# Allowable Differences Between S-52 and S-101 Display and Functionality in ECDIS

#### S-101PT11-8.2 19 Sep 2023

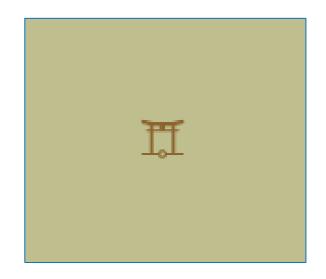
- A new symbol has been added for Torii which is new category of landmark value
- Principle 1 applies not in S-4 but considered adequately intuitive as shape reflects the real-world feature

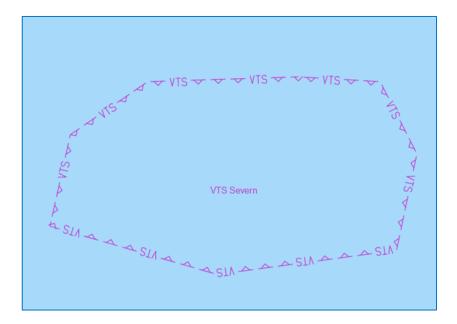
- New symbology has been introduced for VTS Areas as a new S-101 feature
- Principle 2 applies use of text in linestyle should ensure this is intuitive
- <u>Vessel Traffic Service Area · Issue #50 · S-101-Portrayal-</u> subWG/Working-Documents (github.com)

#### **IHO** EMERGENCY WRECK MARKING BUOY

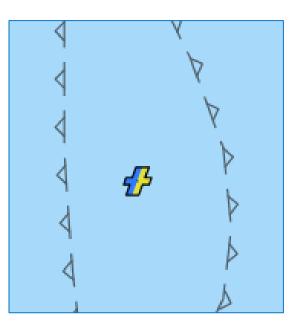
- A new symbol has been introduced for Emergency Wreck Marking Buoy
- Principle 2 applies here the symbol is considered intuitive as it reflects the real-world colour of these marks and the shape of the topmark which is consistent with existing simplified symbology

- Currently only a simplified symbol has been included in the Portrayal Catalogue
- It is understood that this is predicated on an assumption that colour filled buoyage symbols will be adopted

### IHO SECTOR LINE LENGTH

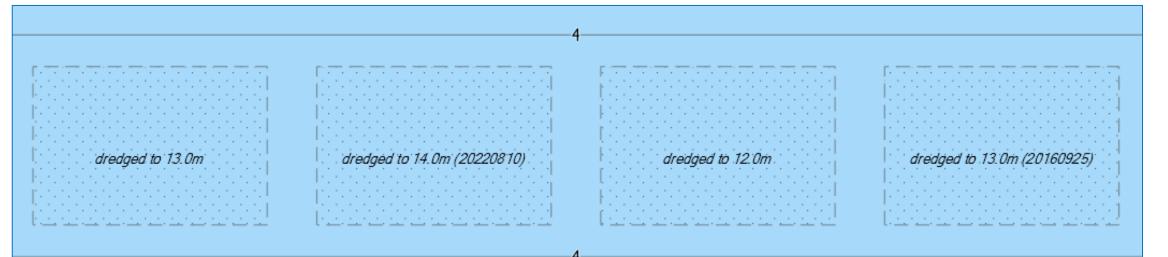
- The text displayed for dredged areas has changed from S-52 which displayed no text
- Principle 1 applies and S-4 B-414 refers, suggest that review is needed
- Need to confirm rules reflect distinction between areas regularly maintained and those not, also need to consider the potential for clutter here and use of Scale Minimum on the text may need consideration (Text Placement currently limited to Point features)
